ADDENDUM NUMBER 03

DATE: January 31, 2024

PROJECT: Cass District Library Edwardsburg, MI

PROJECT NUMBER: 22-1836

1
3.3 T&G DETAIL
3" = 1'-0"

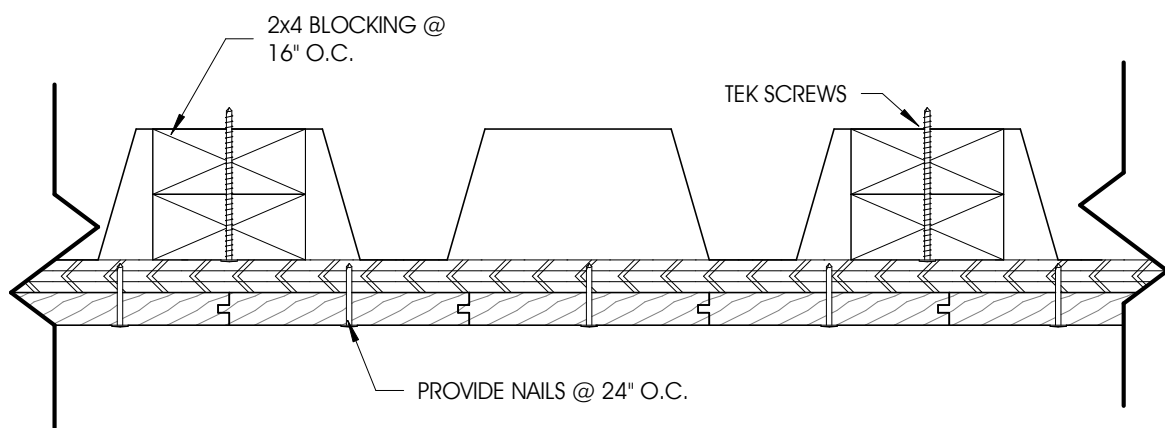
1. **REVISE** Bid Schedule
 - a. Bid due date will be due at 5:30 pm on February 7th, 2024, not 6:00 pm.
2. **ADD** Voluntary Alternates
 - a. All Voluntary Alternates shall be provided on the contractor's letterhead and shall identify this project by name and number.
3. **REVISE** Structural revisions shall be provided in ADD #4 on February 01, 2024.
4. **ADD** Appendix #3.3 T&G CEILING DETAIL for Alternate #11.

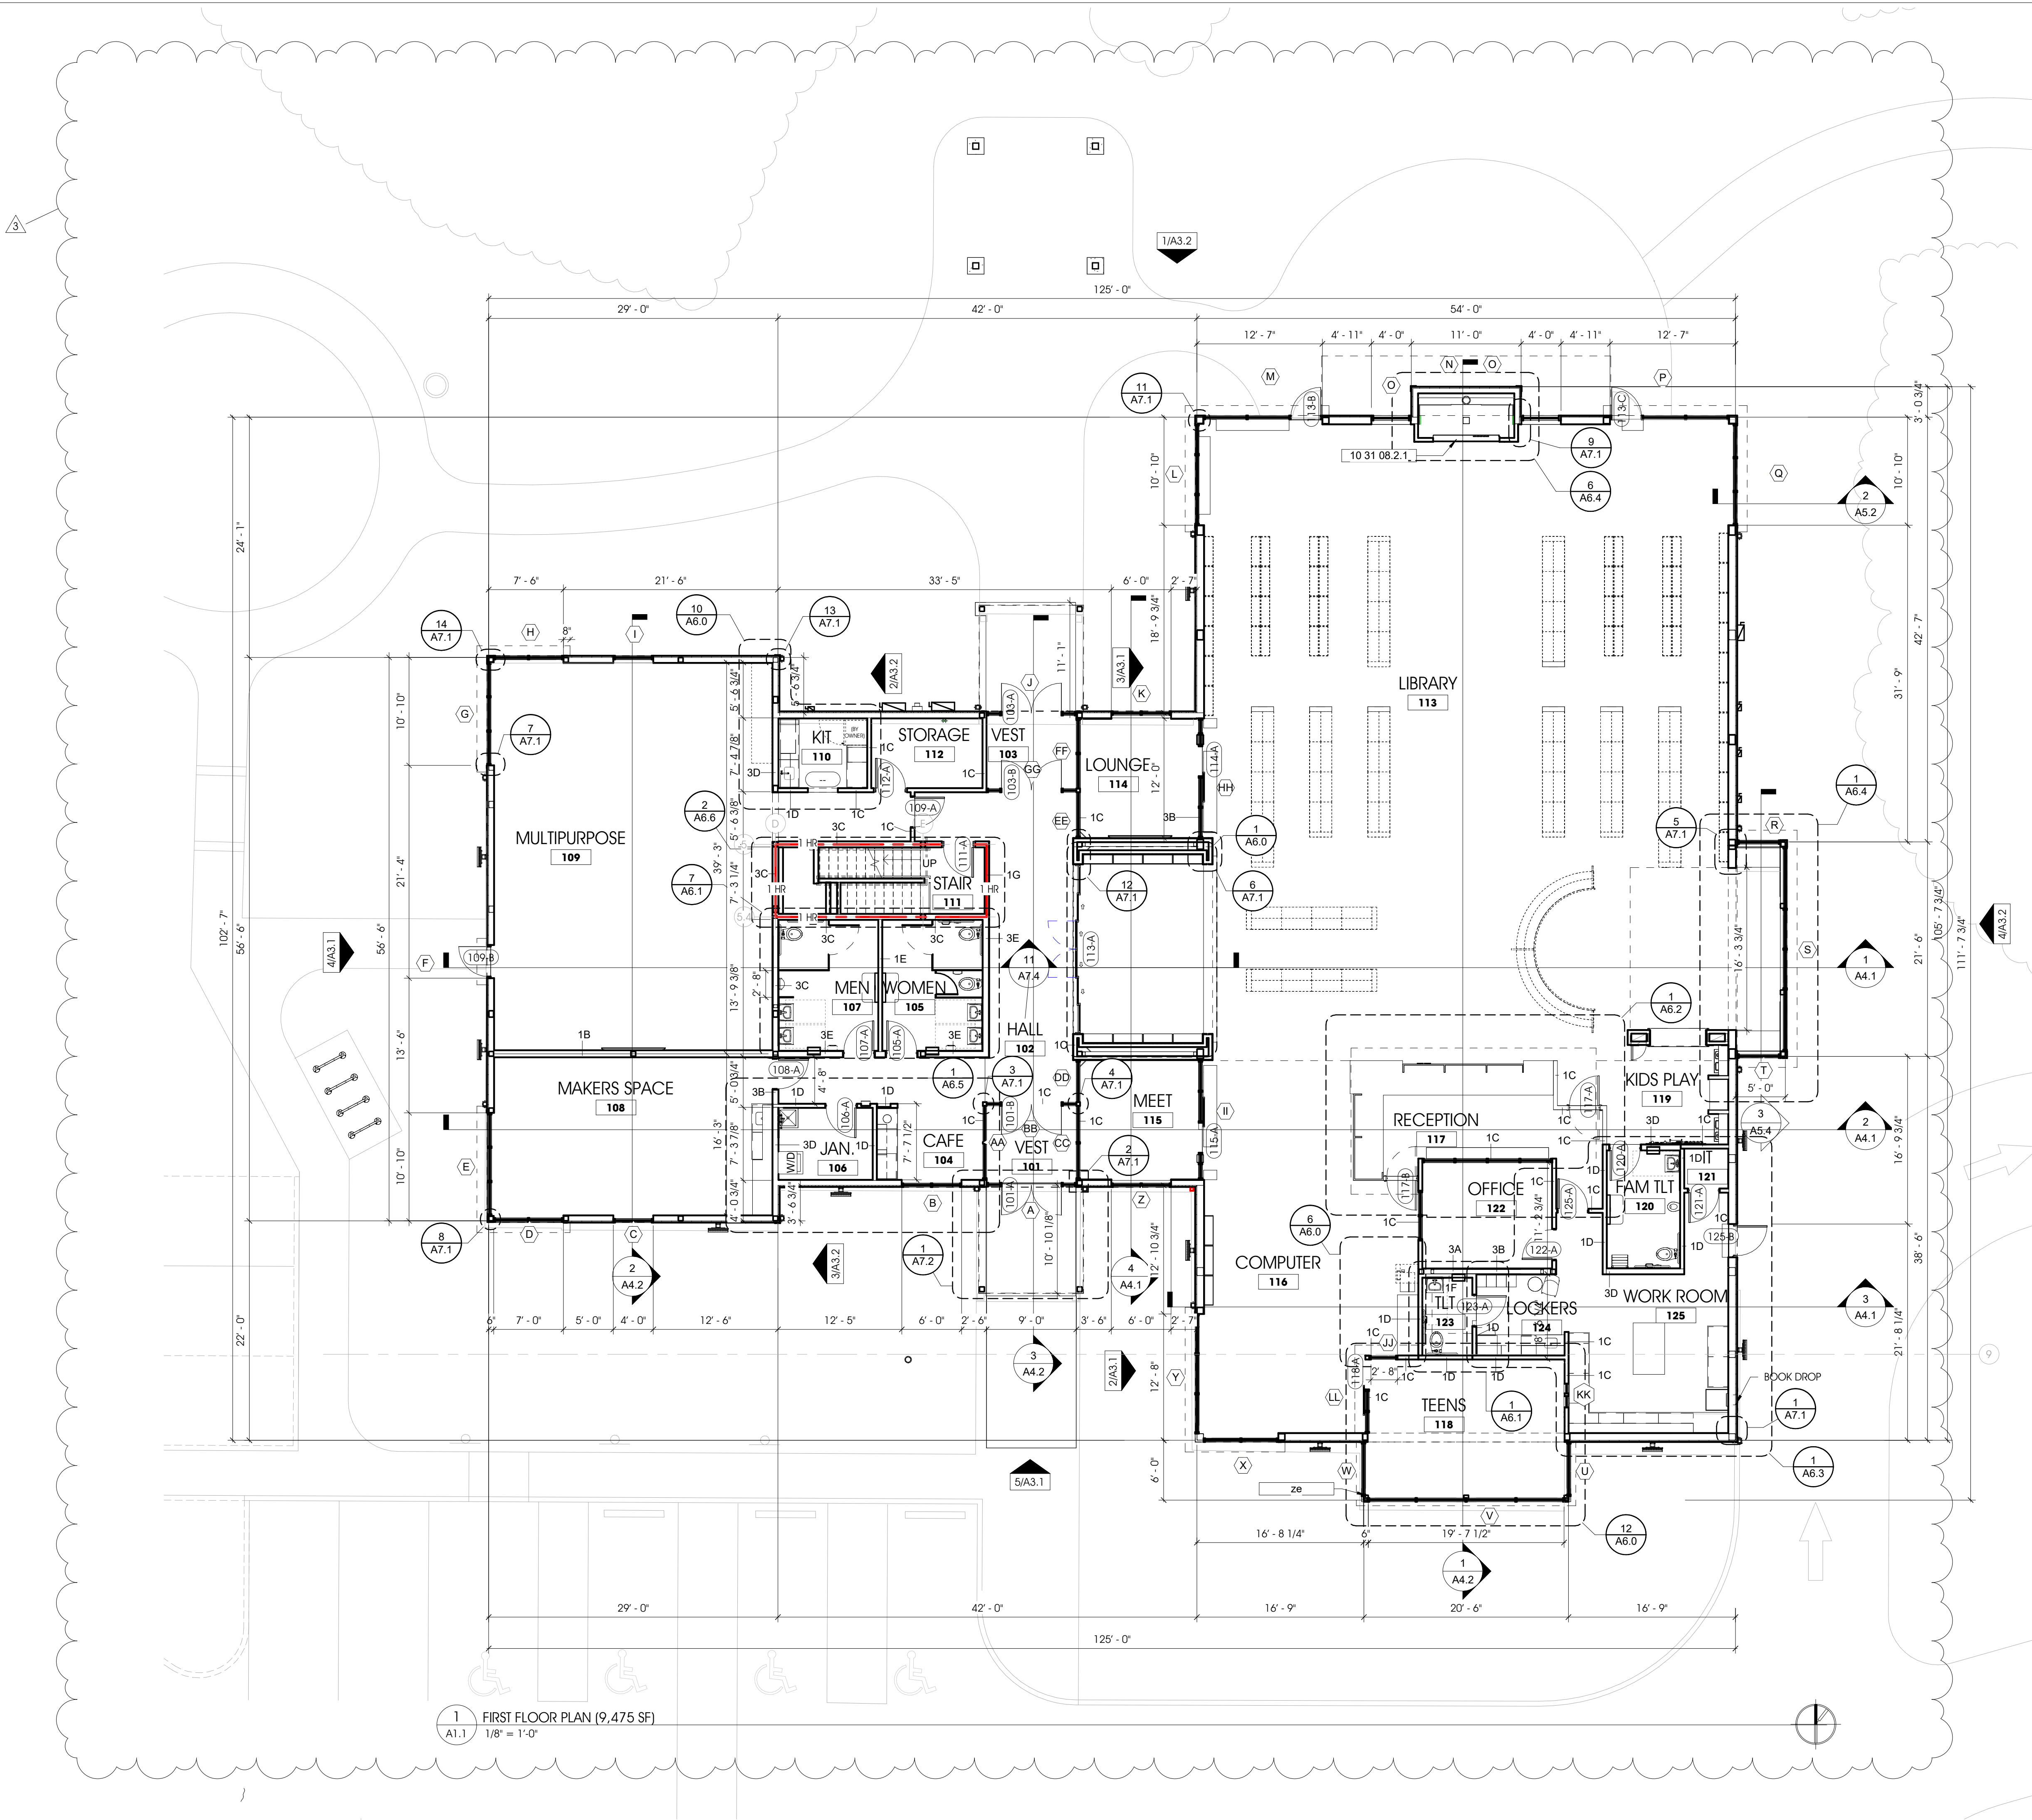
9. **REVISE** Plant quantities and locations

- a. Please see **Appendix #3.1** for clarification.
40. Please clarify quantities of River Birch, Ozark Witch hazel, and Happy Returns Daylily.
- a. Please see revised sheet C6.0 LANDSCAPE PLAN & C6.1 LANDSCAPE PLAN for quantities.
